Hearing Examiner Staff Report and Recommendation

Project Name: Ives Mill preliminary Plat

Type of Application: Preliminary Plat

Permit Number: 23-02854

Attachment A – Preliminary Plat Site Plan

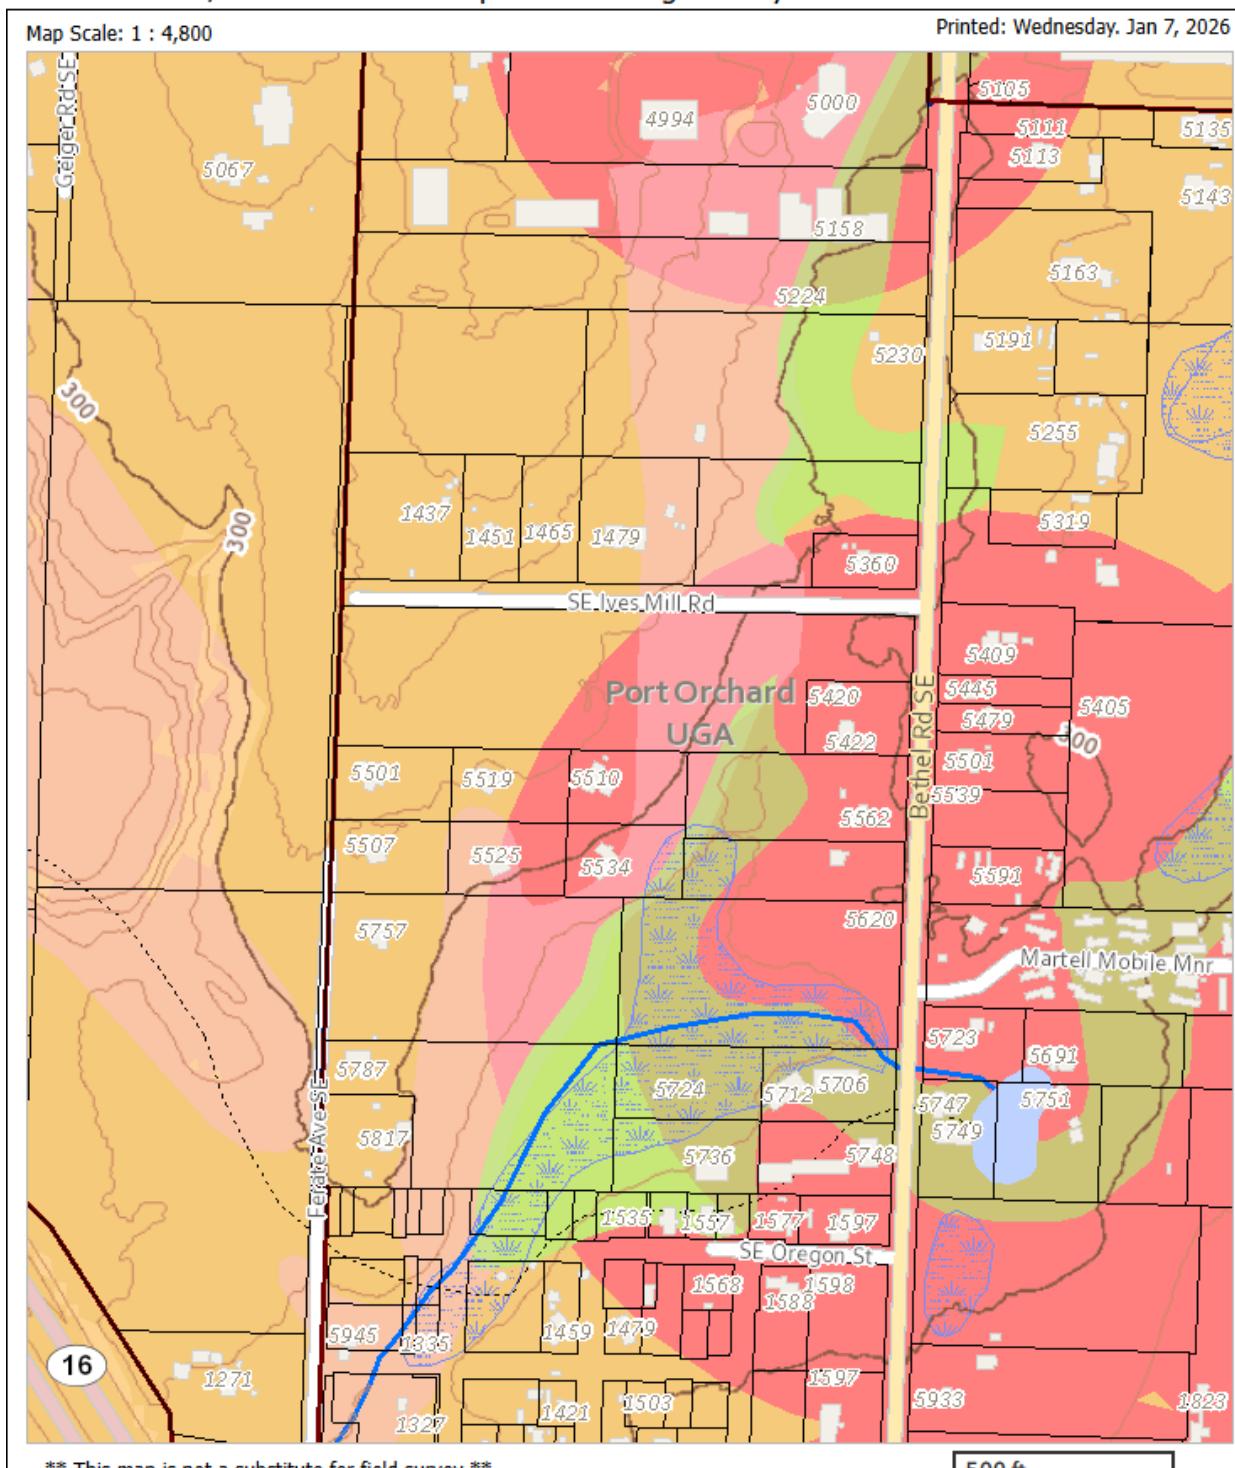
Staff comment: On the landscape plan titled under the previous name, the applicant is proposing a variety of street trees from e.g., Norway Sunset Maple, Princess Diana Service Berry to Golden Rain Trees with a caliper size 1.5". Per KCC 17.500.030.C and D, the minimum caliper size is 2"caliper, generally 25 to 35 feet. The Landscape plan be required to minimum 2".

3. A Final Landscape Plan will be required to be submitted with the Site Development Activity Permit (SDAP), consistent with Kitsap County Code 17.500 Landscaping, during civil site plan review, which depicts natural vegetation, and the planting and irrigation plan. The tree retention plan shall be included with the SDAP.

4. Street trees shall be planted along the access driveway and on individual lots at approximately 25' spacing. A final landscape plan will be subject to approval by the Department prior to SDAP approval. Trees on individual lots are required to be installed prior to the Certificate of Occupancy of individual residential units.
